**ADDENDUM NO. 5  
TO  
Natomas Mutual Water Company  
American Basin Fish Screen & Habitat Improvement Project  
Sankey Diversion and Canal Facilities**

This Addendum No. 5 consists of 12 pages plus Exhibits A through G as described in the Exhibits Table of Contents following Page 5-12 of the Addendum. It is the responsibility of the Bidder to assure and guarantee by acknowledging the receipt of this Addendum in the Bid Form that the Bidder has received the addendum in its entirety, and that the Bidder accepts all conditions contained herein.

**EXHIBIT G**  
**Volume 5**  
**Schedule B**  
**Revised Contract Drawing C-701**

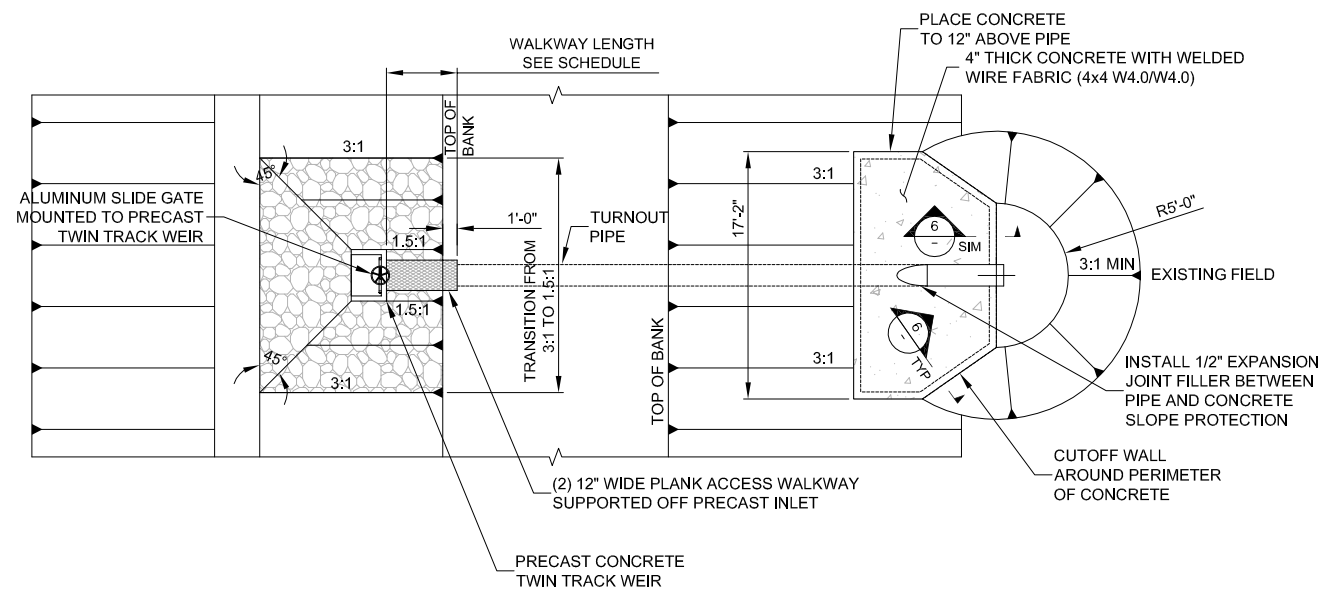
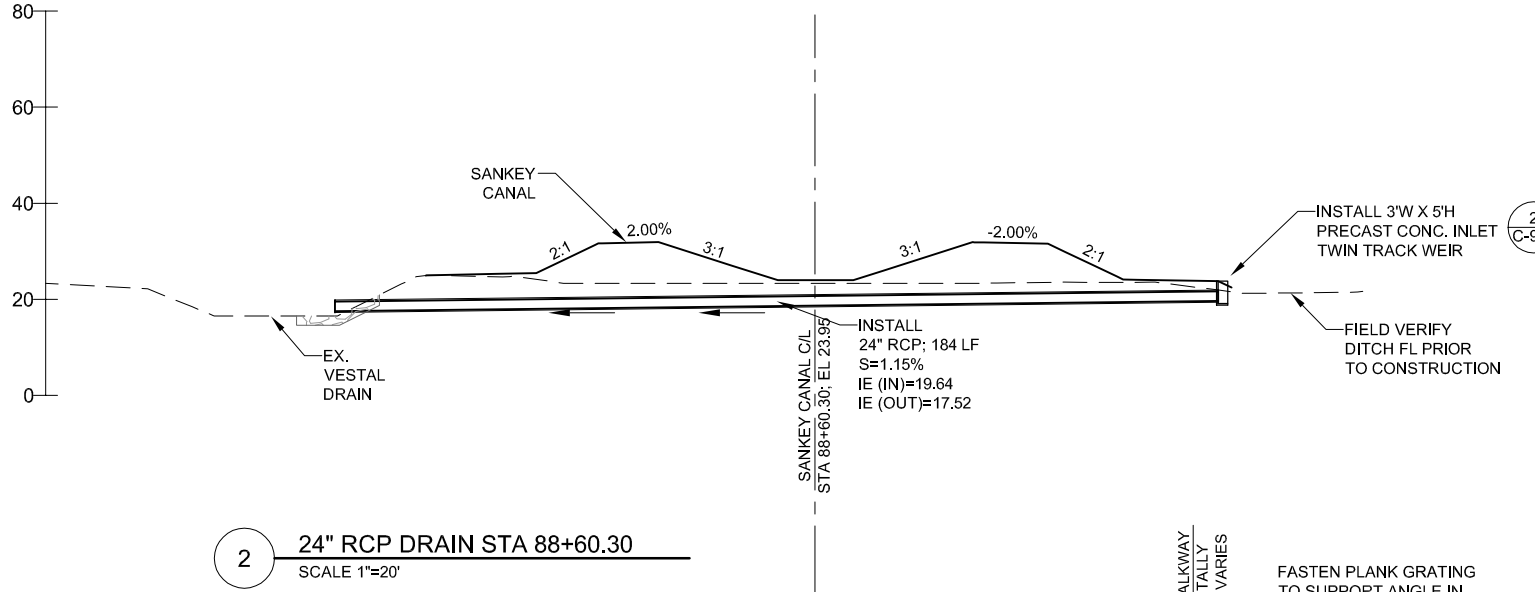
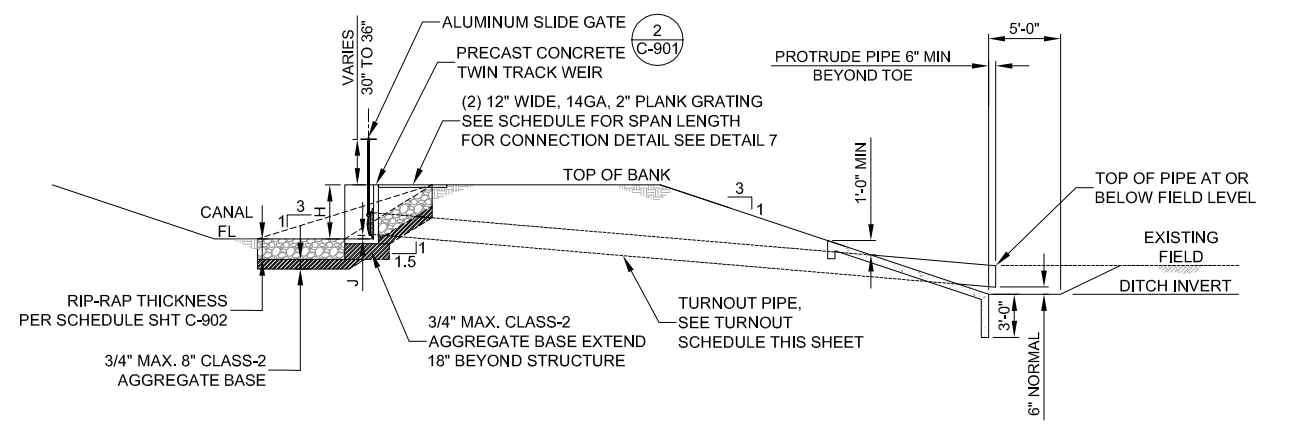
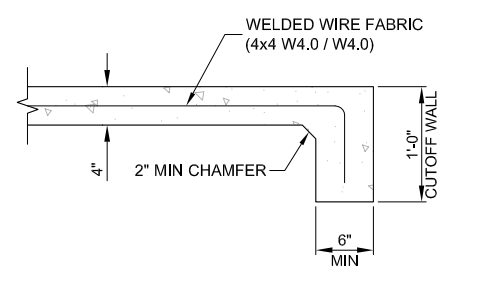
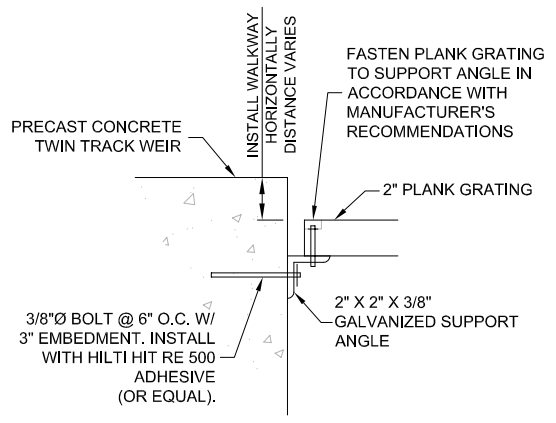
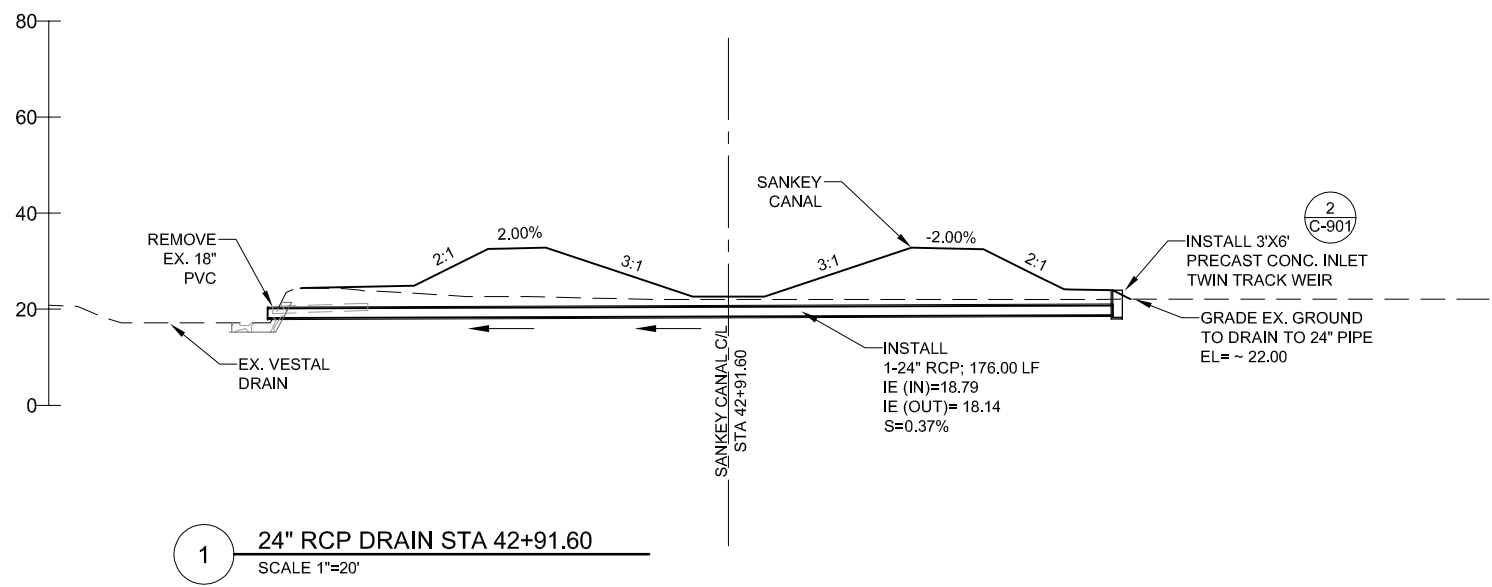
31. DRAWING NUMBER C-701 – FIELD DRAIN - TURNOUT

Delete Drawing No. C-701 in its entirety and replace it with revised Drawing No. C-701 as contained in Exhibit G of this Addendum No. 5.
